APPENDIX 11D — PUBLIC COMMENTS 2025

Public Comment Log and Bates-Stamped Page Index

APPENDIX 11D – PUBLIC COMMENTS 2025	ARONFA-2-01	SITE PLAN	
	NOVEMBER 2021	SEPTIC DRAIN FIELD IMPROVEMENTS AURORA, OR	FIGURE 2 A11D0234

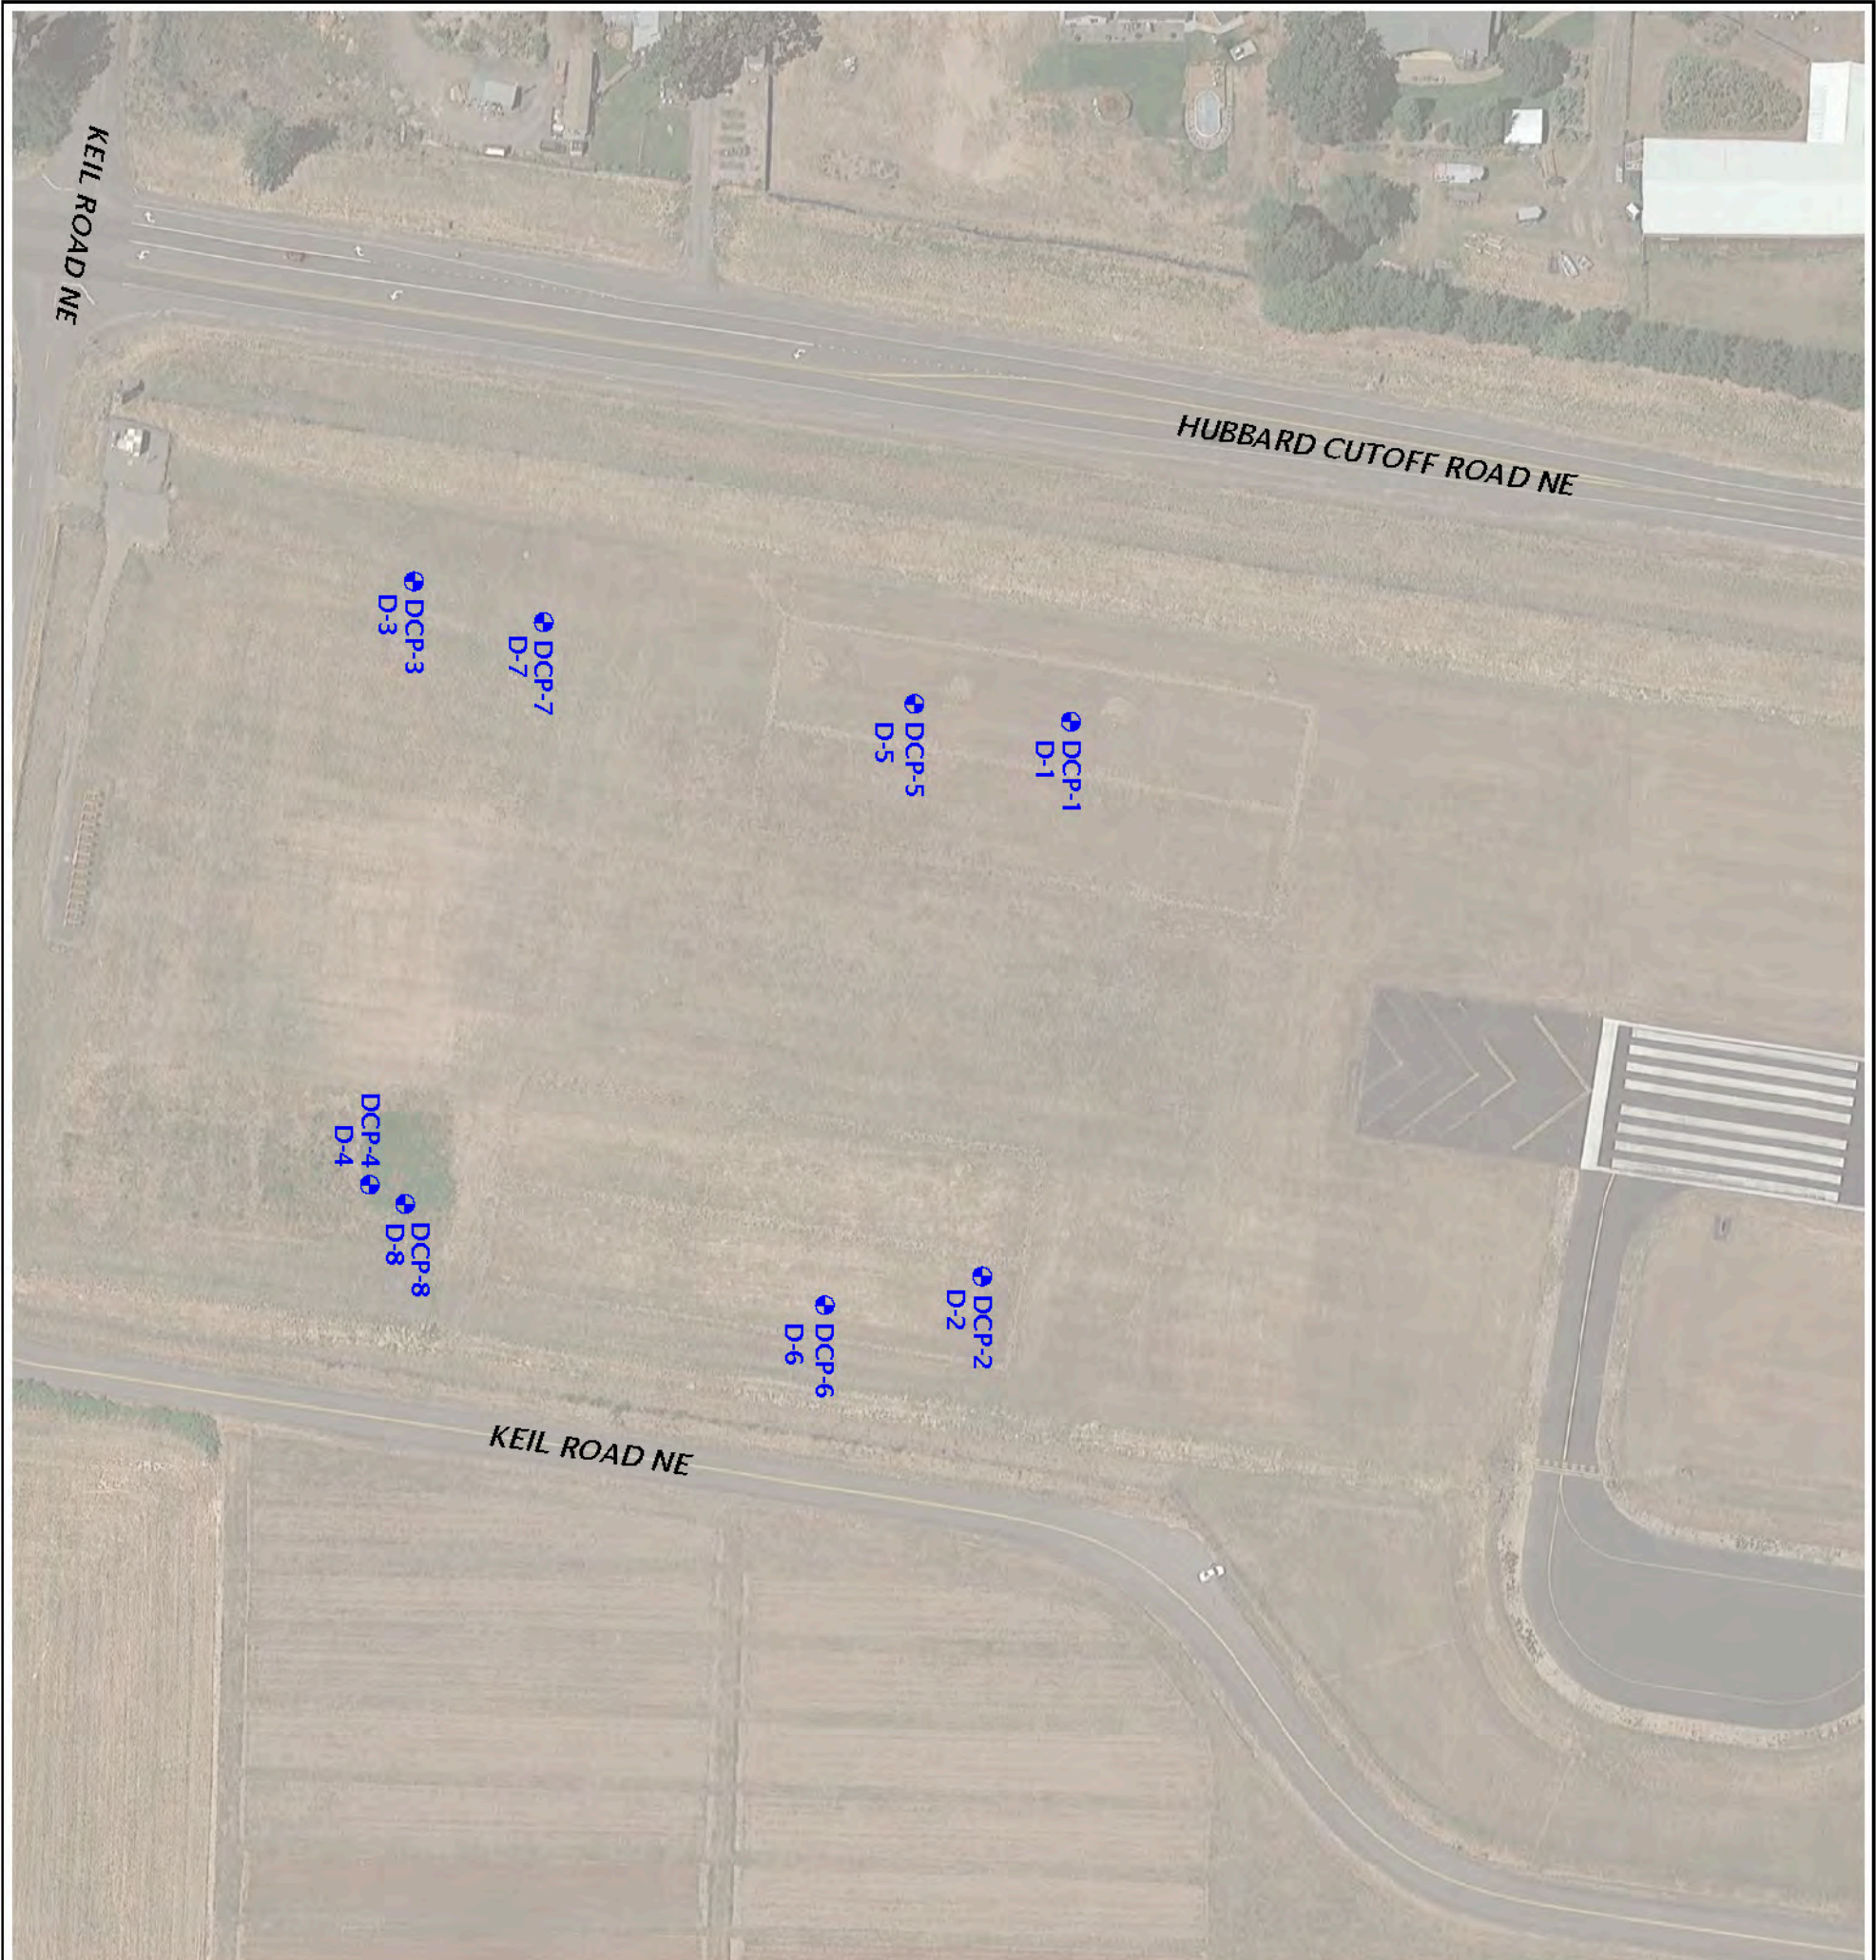
- Report figures
 - o Figure A-1: graphic does not show up in the provided pdf
 - o Figure A-2: graphic does not show up in the provided pdf
- “Such stringent compaction is not permitted in the soil cover of drain fields”
 - o Where does this statement come from?
